Re: Docket No. 492 - Gravel Pit Solar – Application for Certificate of Environmental Compatibility and Public Need for the construction, maintenance, and operation of a 120-megawatt-AC solar photovoltaic electric generating facility on eight parcels generally located to the east and west of the Amtrak and Connecticut Rail Line, south of Apothecaries Hall Road and north of the South Windsor town boundary in East Windsor, Connecticut and associated electrical interconnection.

Acoustical Assessment

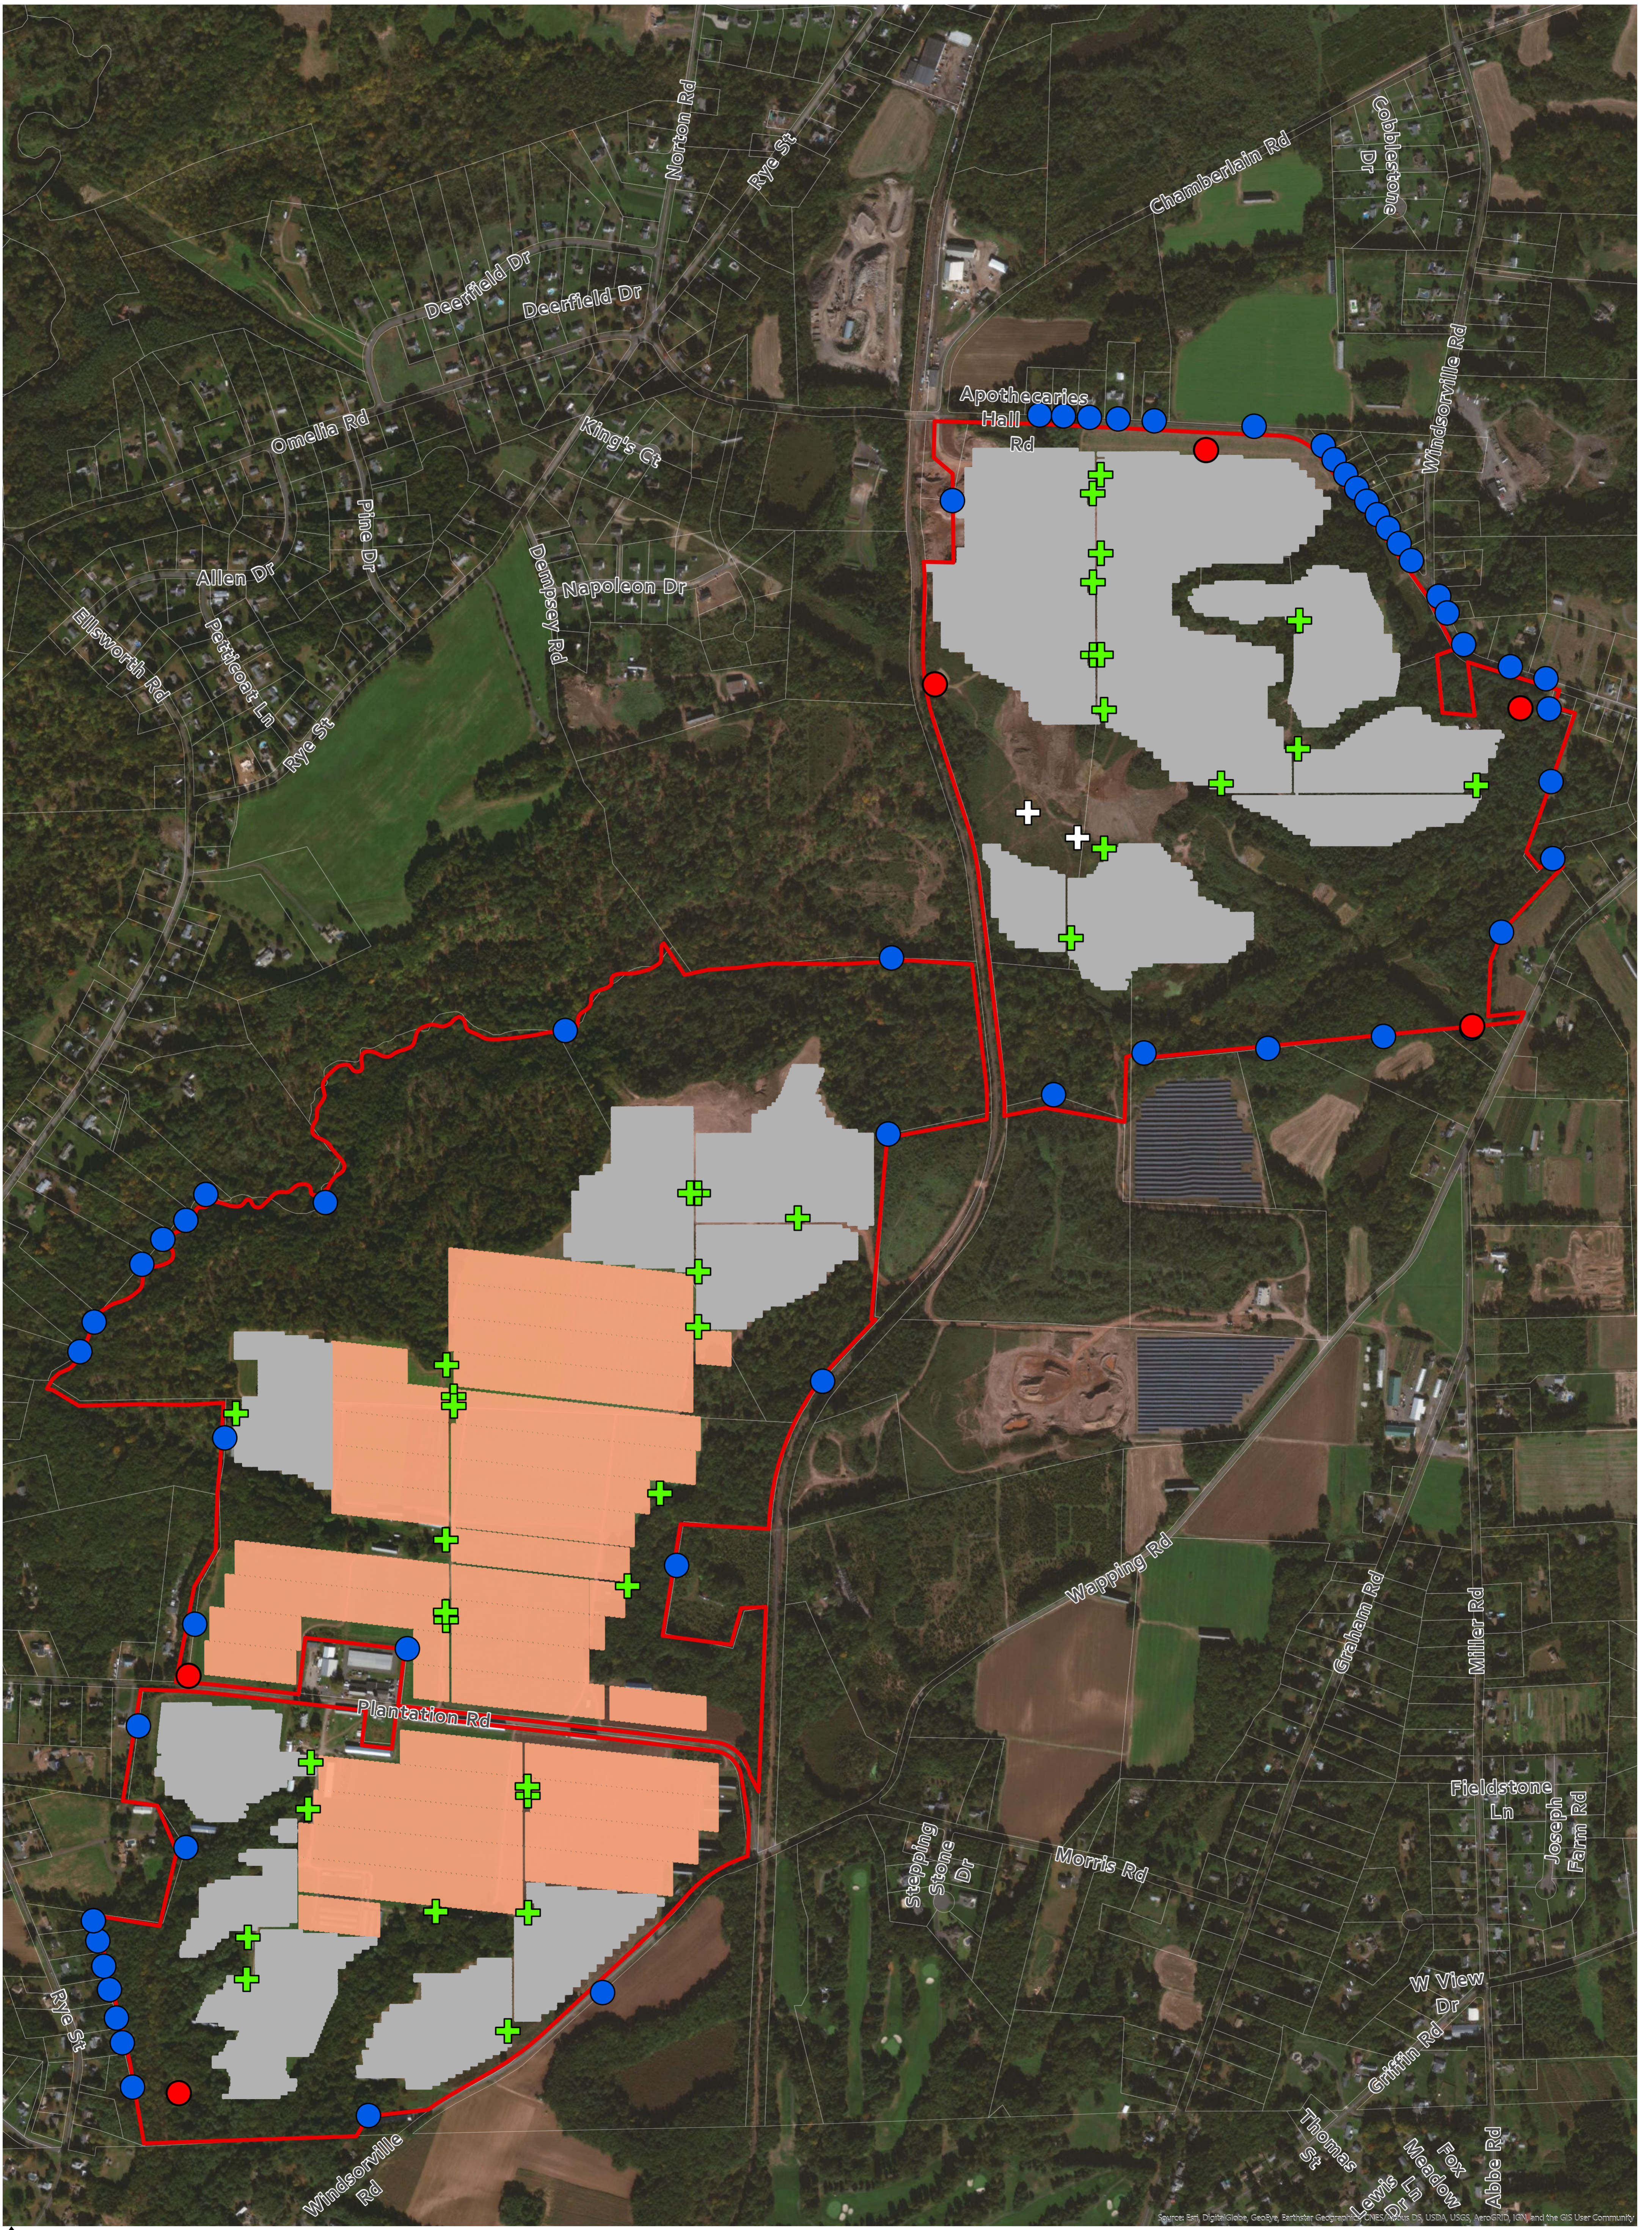
Finally, VHB was retained by GPS to evaluate the sound impact for this project, given the proposed modules, inverters and layout of the project. VHB informed GPS that the expected sound levels are in compliance with the DEEP’s regulatory limits. Specifically, VHB’s analysis evaluated the potential sound level impacts from the 40 inverters (Sungrow), two transformers and 300 tracking system motors

operating simultaneously. The sound levels attributed to the proposed equipment ranges from 17 dBA to 49 dBA. During the daytime period, the receptor locations will experience overall sound levels (ambient plus project contributions) ranging from approximately 35 dBA to 50 dBA. These sound levels are below CT DEEP's daytime criteria of 55 dBA. Due to the nature of the Project, the equipment will not be operating during the nighttime period. An Acoustic Assessment Figure from VHB supporting this finding is enclosed with this letter.
